DATE: August 24, 1994

SUBJECT: MIDSHIP GEARBOX DRIVE FLANGE DESIGN

SERVICE BULLETIN #56  
August 24, 1994

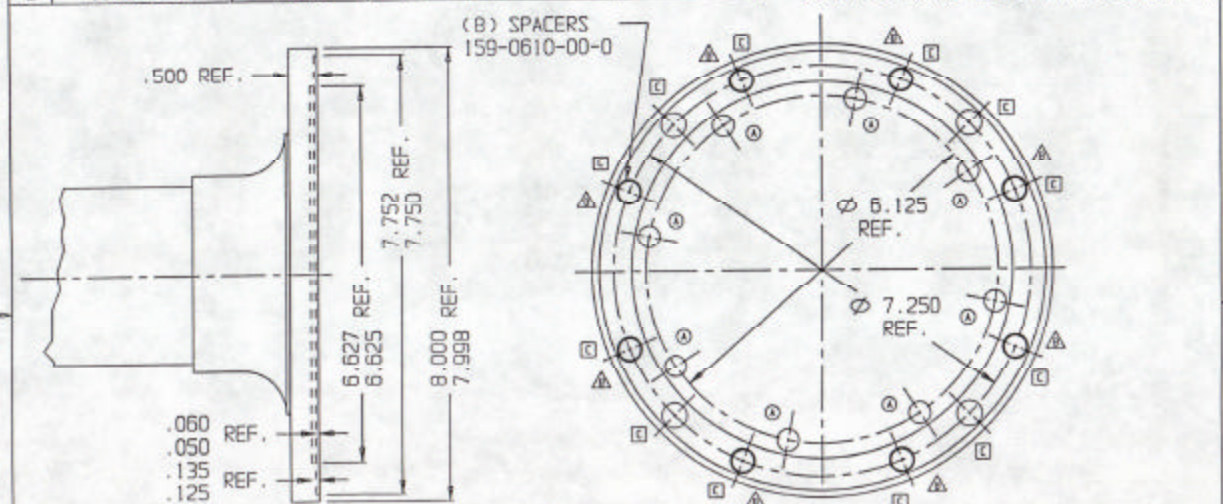
In addressing the potential to omit inserting the spacers, we advise you of a change in the method of supplying the eight (8) spacers with each pump flange at time of shipment. Effective immediately the eight (8) spacers required for use in 1700 Series applications will no longer be shipped loose. Since the 1700 Series drive line is used most frequently, we will be inserting the eight (8) spacers in the appropriate position in our Drive Flanges. For 1800 Series flanges they can easily be tapped out and discarded. (See the attached drawings.)

This bulletin reiterates the information provided on our reference drawings, that only Grade 8, drive line bolts, of the proper size, should be used on all companion flanges and always use spacers when they are required. Failure to comply with the above recommendations can cause serious problems; vibrations, loosening of bolts and possibly, loosening of flanges.
